South Texas Project Electric Generating Station P.O. Box 289 Wadsworth, Texas 77483

August 21, 2002  
NOC-AE-02001368  
STI: 31470189

South Texas Project  
Units 1 and 2  
Docket Nos. STN 50-498, STN 50-499  
Proposed Changes to Technical Specifications 3/4.4.1.4.2 and 3/4.9.1

## Description of Changes and Safety Evaluation

Figure 1: Example Alternate Isolation Locations

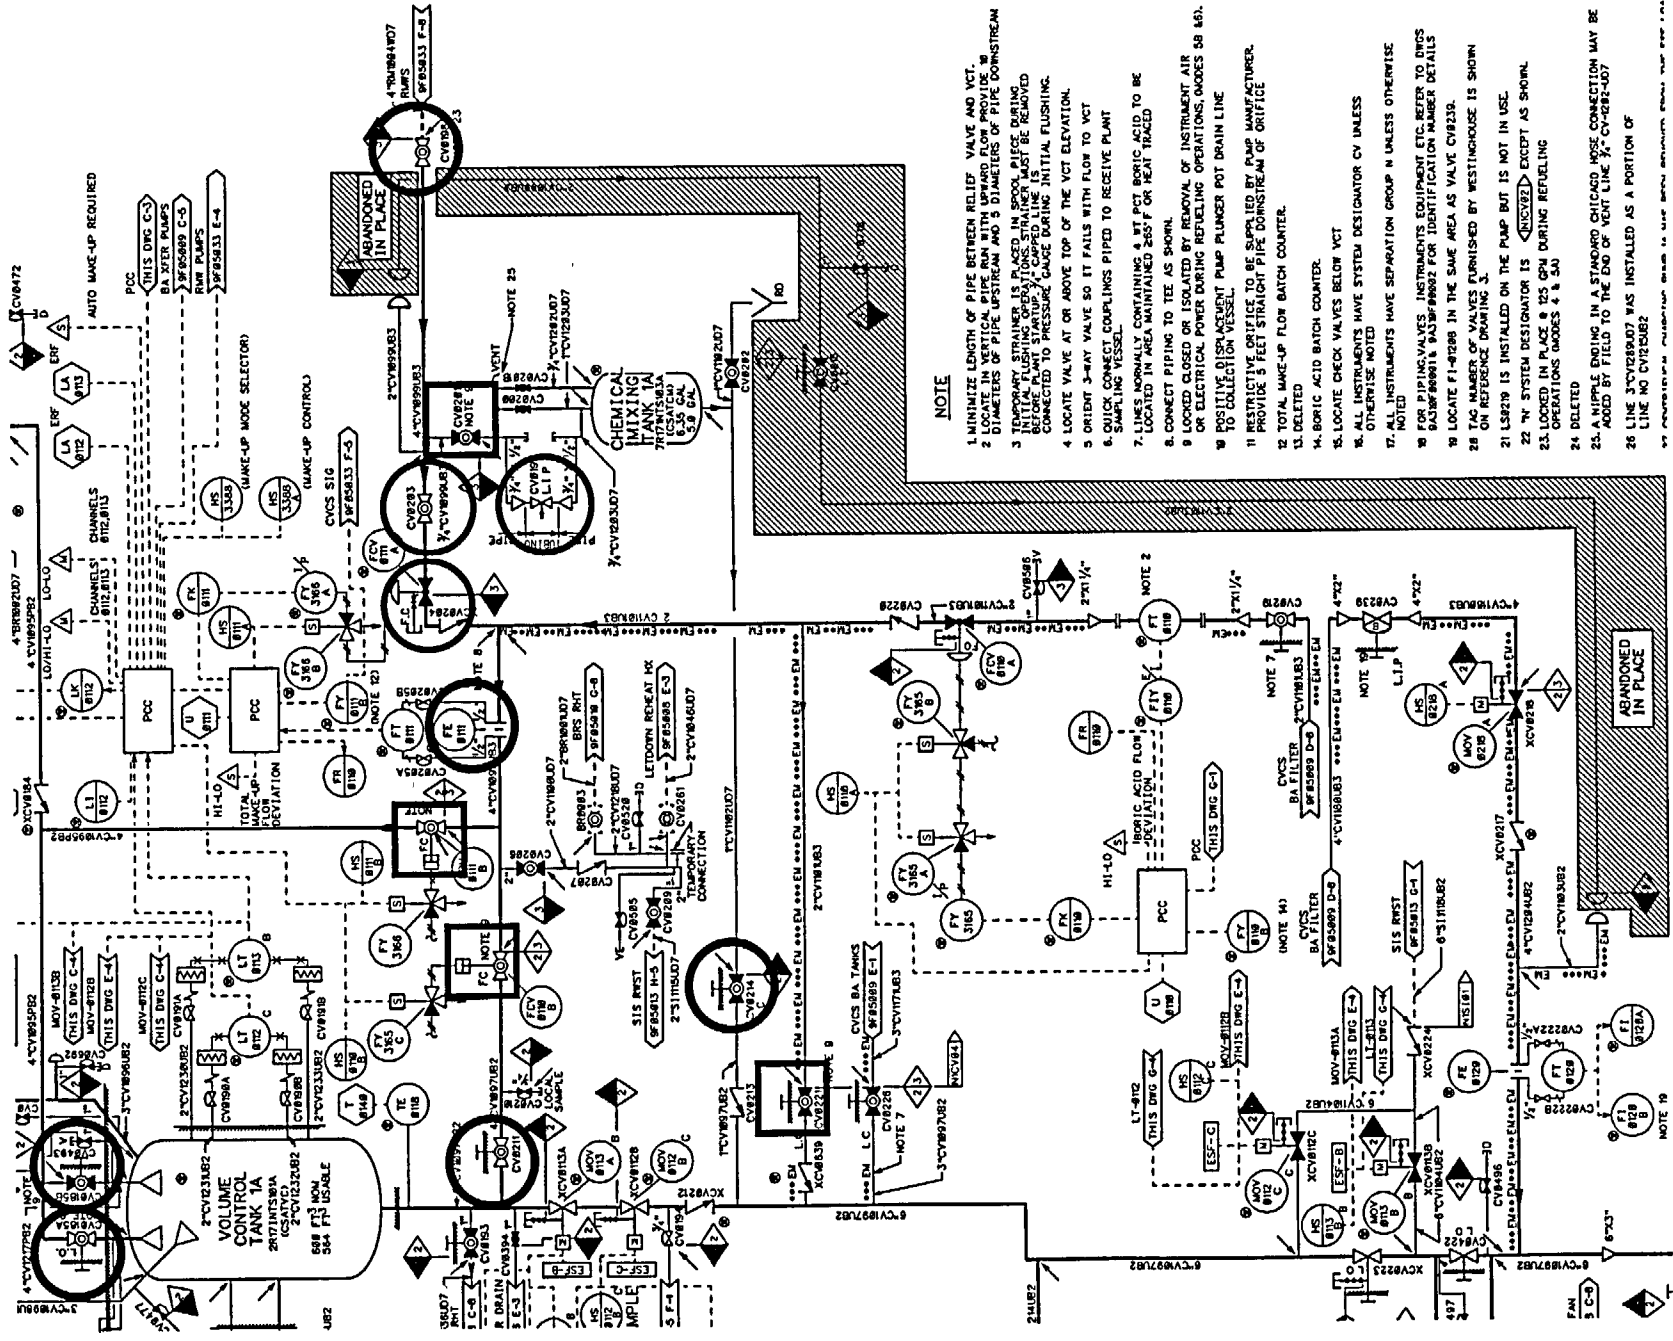
The specific changes are described in the table below. The proposed new wording for the subject TS does not specifically identify which valves must be used to isolate the potential boron dilution pathways; however, there is no change in the requirement that the pathways be isolated. The proposed change is consistent with the provisions of the Improved Standard Technical Specifications for Westinghouse plants (NUREG-1431). The details of how the pathways can be isolated will be provided in the Bases. The draft text proposed for the Bases is also provided in the table. Figure 1 (STP UFSAR Fig. 9.3.4-3) depicts the potential dilution flow paths and the alternate isolation points.

Figure 1 depicts the potential boron dilution flow paths. It can be seen that there are alternative ways to isolate the dilution flow paths, as shown below. (This list of alternates may not be complete, but illustrates the options available.)

- a. Close and secure CV-0198 (isolates all flow)  
OR
- b. Secure the pathway through chemical addition line by securing CV-0201A or CV-0214, or CV-0197, and
- c. Secure the pathway through the emergency boration line by securing CV-0203, or FCV-0111A or CV-0221, and
- d. Secure the pathway to charging suction header by securing CV-0203 or FCV-0111A, or installing a blank flange at FE-0111 or securing FCV-0110B or CV-0211, and
- e. Secure the pathway to the VCT inlet by securing CV-0203 or FCV-0111A or installing a blank flange at FE-0111 or securing FCV-0111B or CV-0185A and CV-0185B.

The method of securing the valves in the closed position (remove power or air, mechanical stop, etc.) is not expected to change from that originally required by the TS; however the method does not need to be prescribed in the Technical Specifications.
